City of Duluth Bid # 15-0190

Job Description: Congdon Boulevard Slope Repair
Concrete Retaining Walls at 4 Sites

City Project No. 1324

Addendum #1

TRAFFIC CONTROL - DETOUR
Sheet No. 13 of 86 Sheets

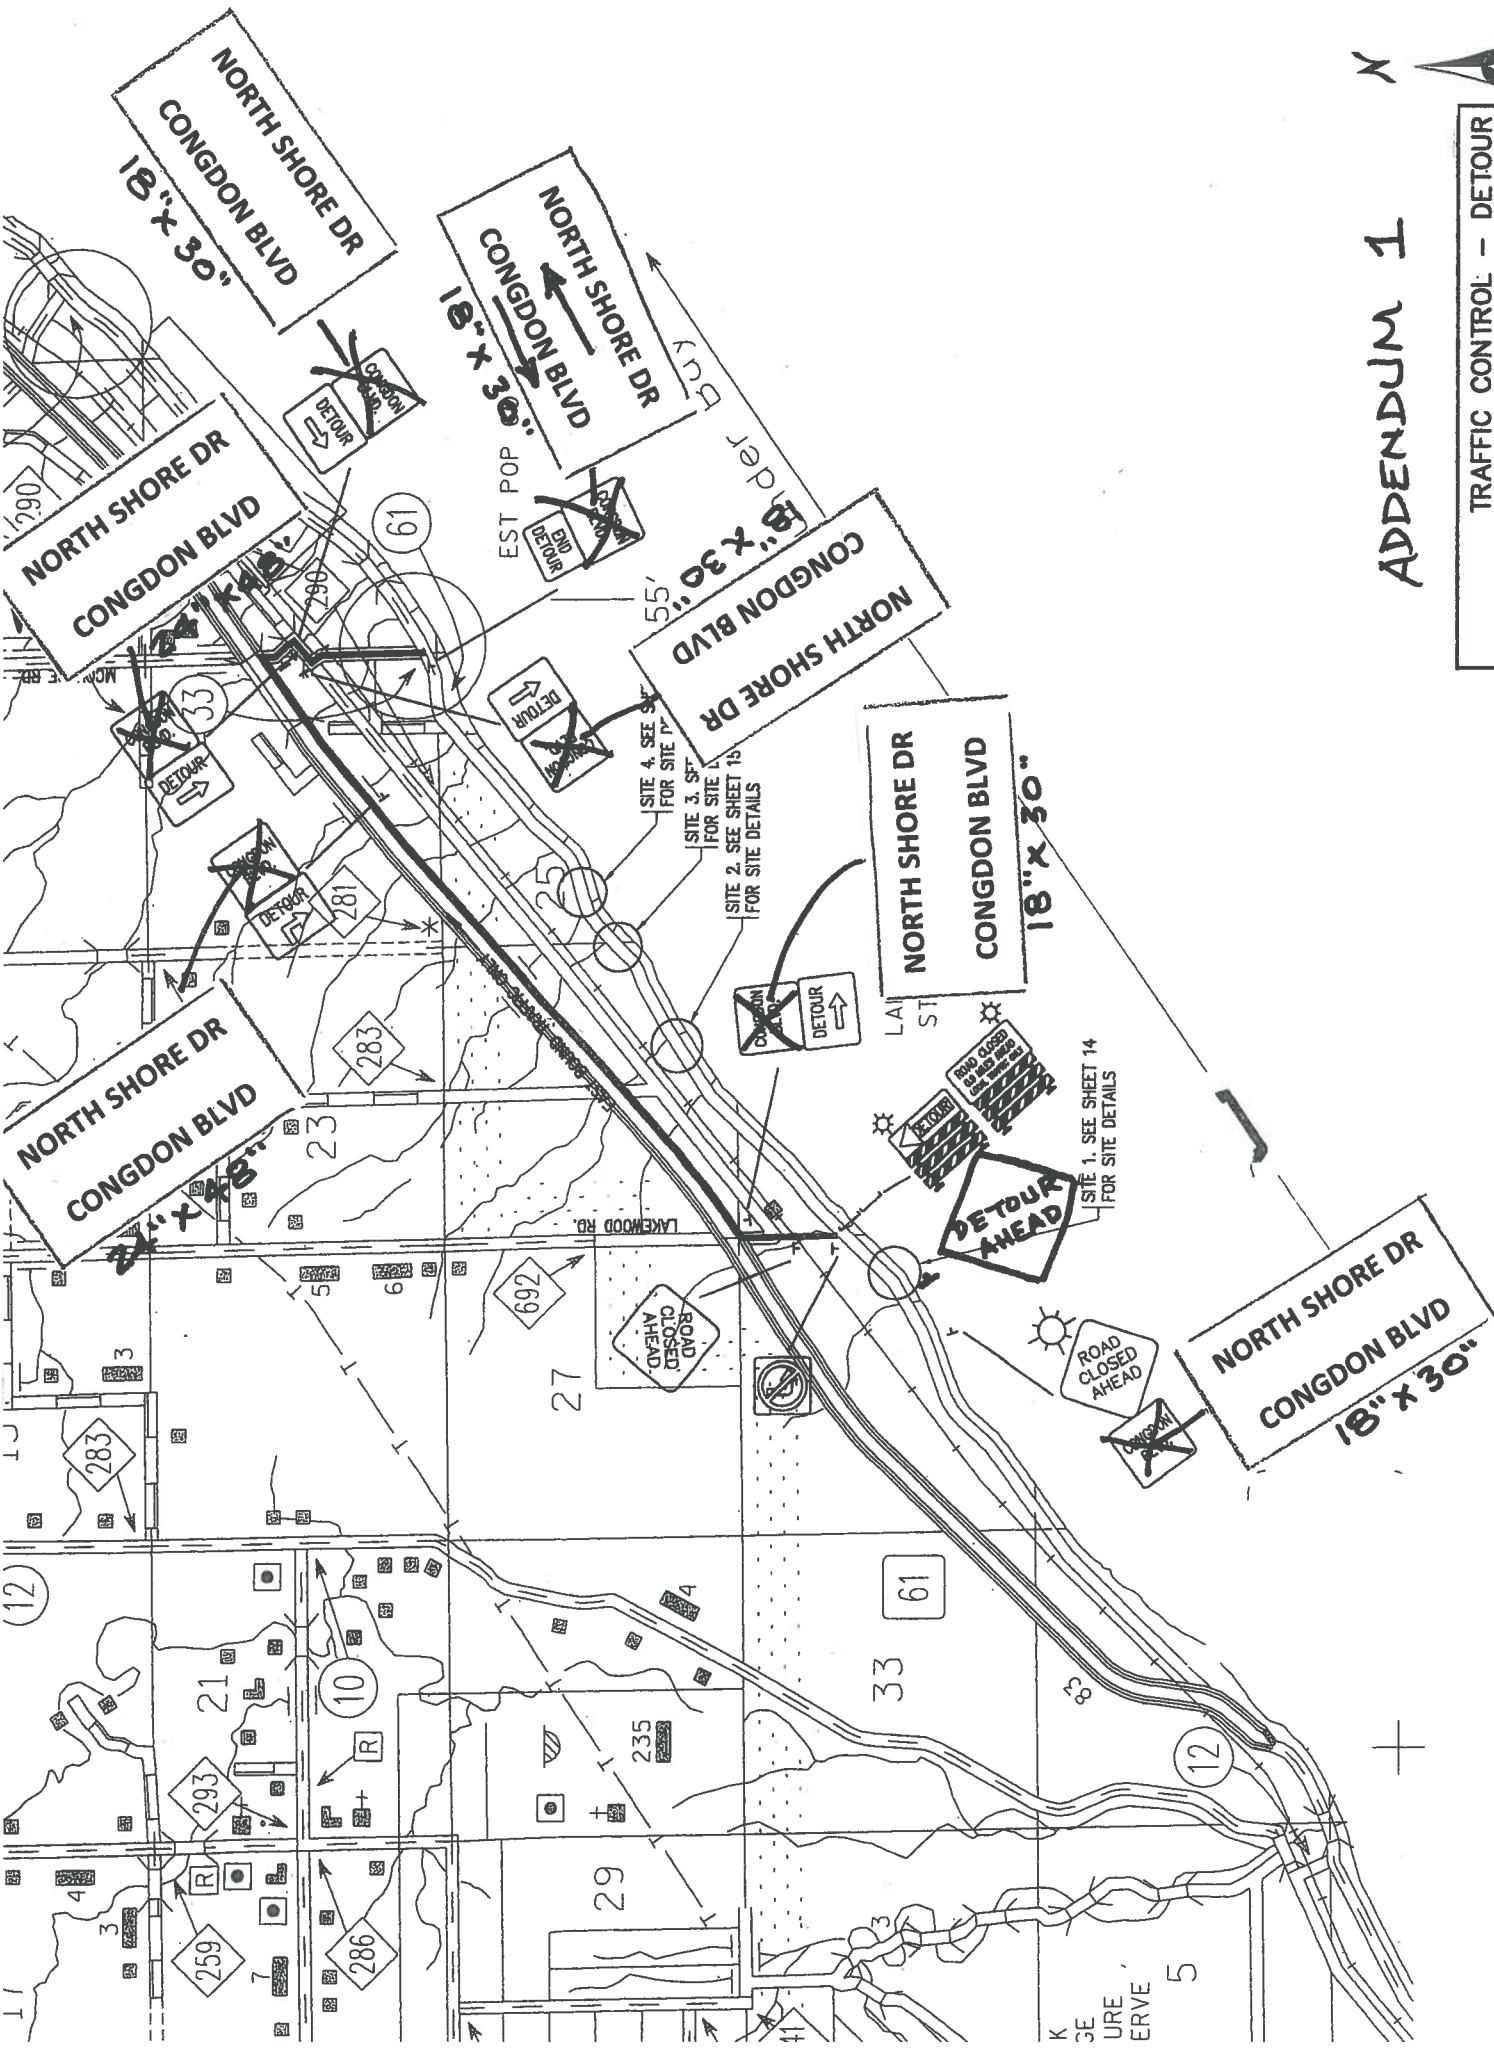
Plan Sheet 13, **Traffic Control – Detour**

The detour signs on Trunk Highway 61 will be larger than the others.

Add "North Shore Dr" text to "Congdon Blvd", increase width of sign panel.

TRAFFIC CONTROL PLAN-SITE 1

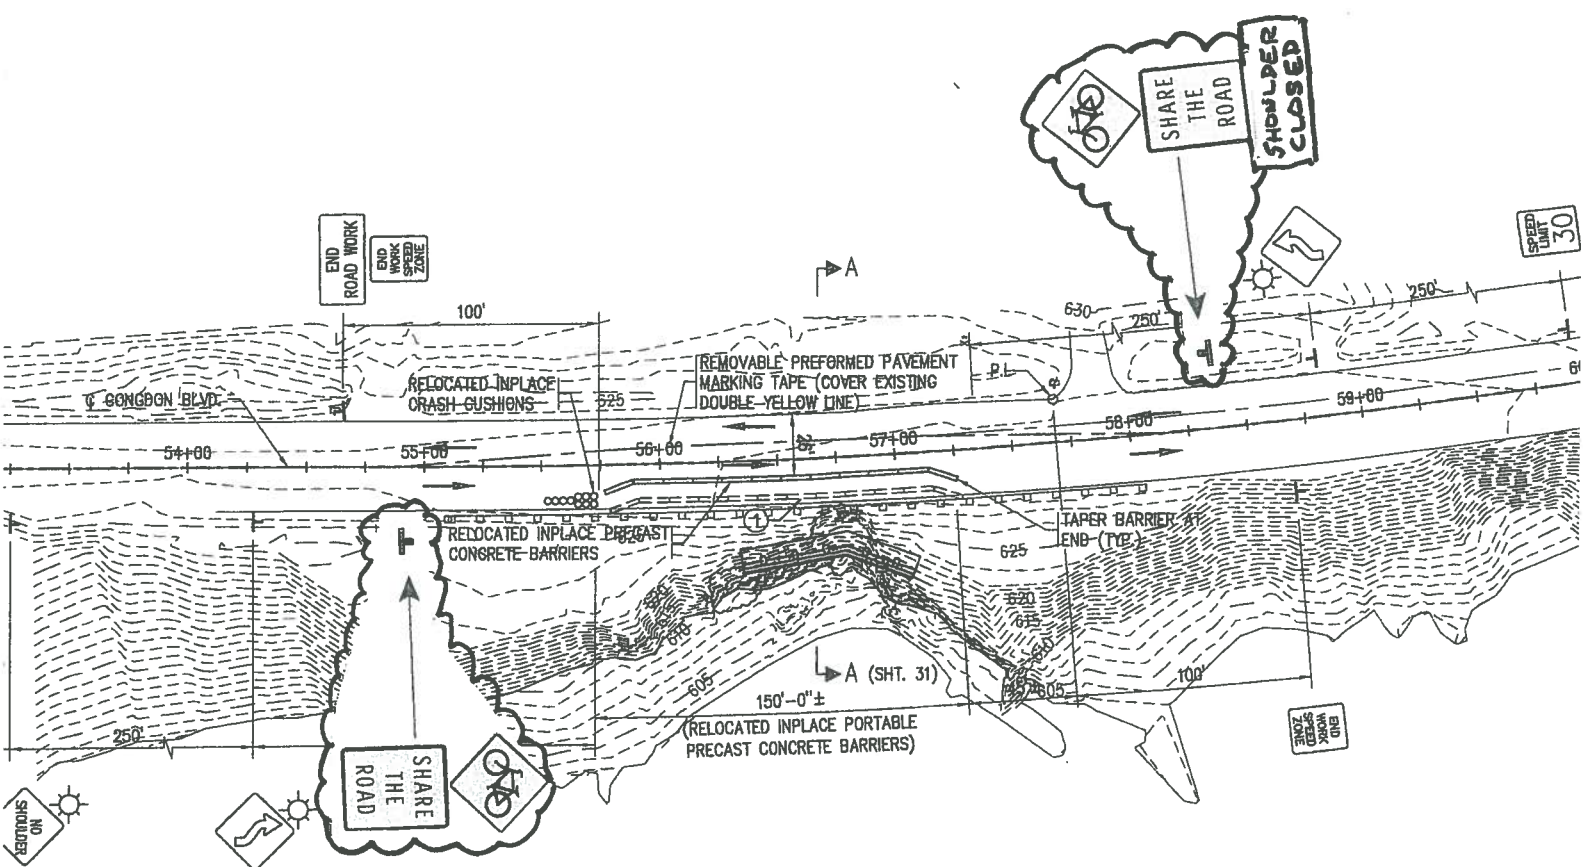
Plan Sheet 14, **Traffic Control – Site 1**

Add Bicycle signage at Site 1 and Site 2. See attached sketches on said Plan Sheets.

TRAFFIC CONTROL PLAN-SITE 2
Sheet No. 15 of 86 Sheets

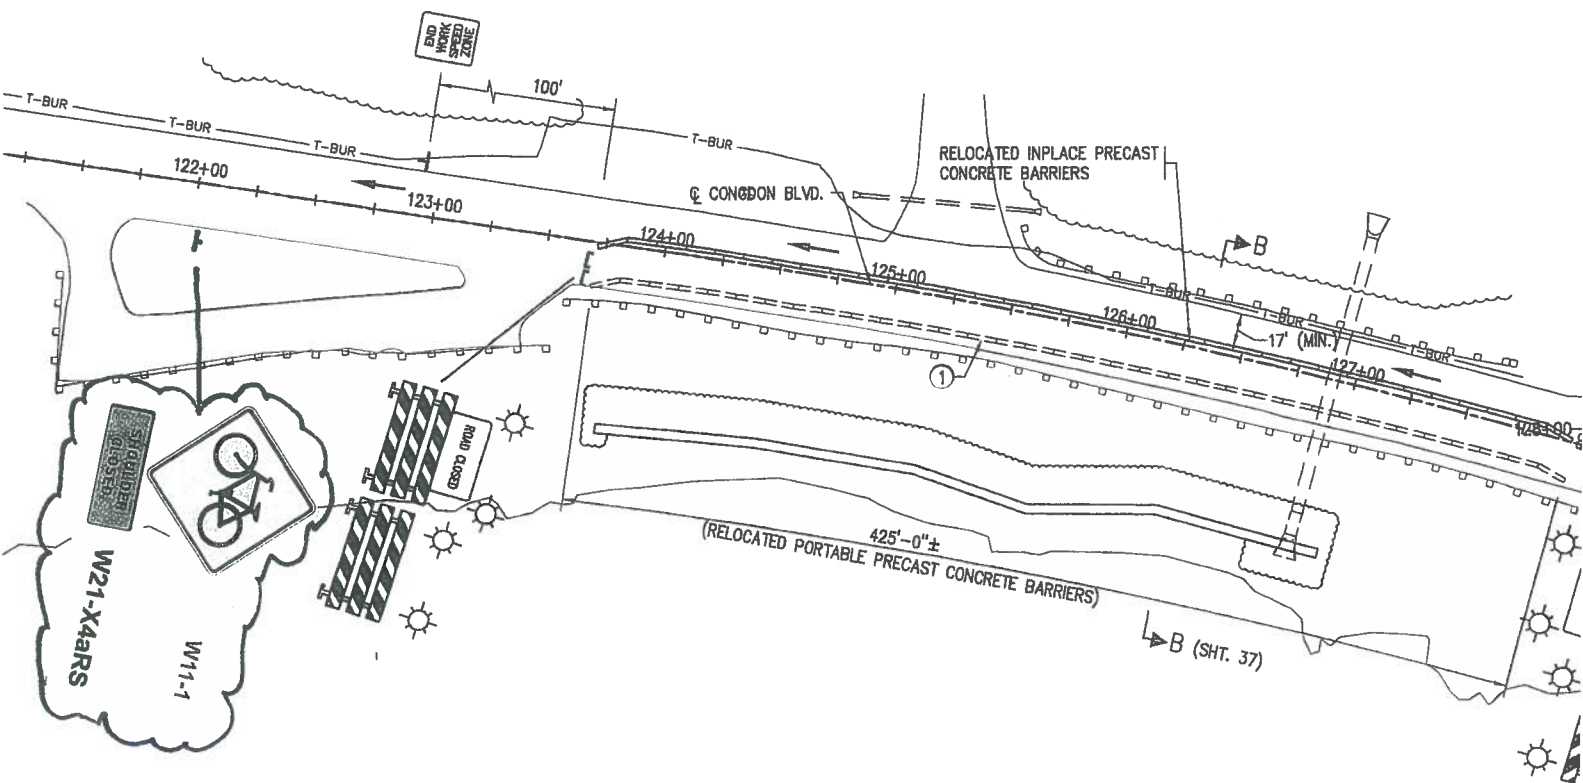
Plan Sheet 15, **Traffic Control – Site 2**
